MONITOR TAP SOUCAN

New, more robust, silicone-free design.

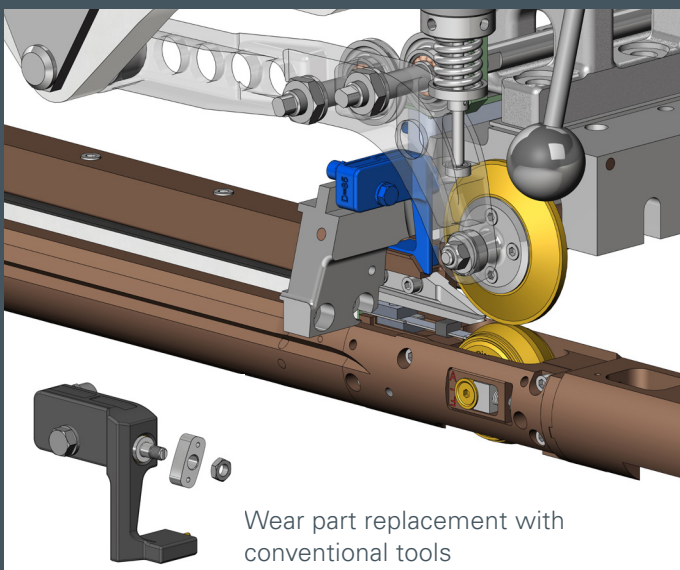
The monitor tap has been redesigned comprehensively. Previously, the cables were inserted in cable guiding grooves, which were sealed with silicone.

In addition, the cable contact point was very exposed and susceptible to damage from crashes and mishandling. Now all components are safely accommodated in a robust housing made with state-of-the-art 3d printing technology. The use of silicone, which can cause problems in the filled product, has been eliminated.
